Subject: Second Supplemental Final Environmental Impact Report (SSFEIR)  
Payne's Crossing  
Assonet, MA

On behalf of the Assonet Bay Action Committee (ABAC), Geo-Hydro, Inc (GHI) has reviewed the SSFEIR for the proposed Payne's Crossing development. GHI's comments on the document are provided below.

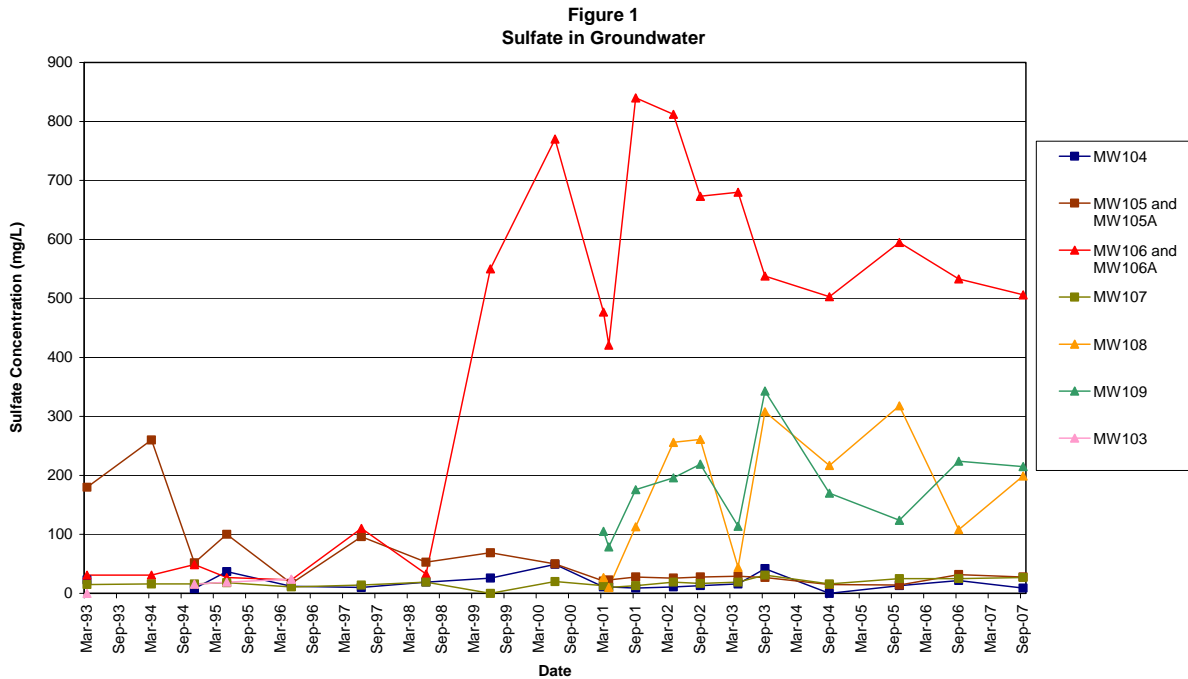
Page 55, Section 3.3 – The description of historical groundwater monitoring indicates that the facility is not having any significant effect on the underlying groundwater table. This characterization misleads the reader by limiting the evaluation only to the last few years of monitoring. When groundwater quality data from the early years on monitoring are compared to

current groundwater quality, it is apparent that there have been large increases in indicator parameter concentrations since the landfill was placed. The attached graph (Figure 1) shows the concentrations of sulfate (an indicator of fly ash contamination) in site monitoring wells from 1993 thru 2007. Prior to 1997 sulfate in MW 106 and 106A was well below 100 mg/l, after 1998 the concentration has ranged from 421 to 840 mg/l. The suggestion that placement of waste in the landfill has not increased the concentration of contaminants in the groundwater is incorrect and misleading.
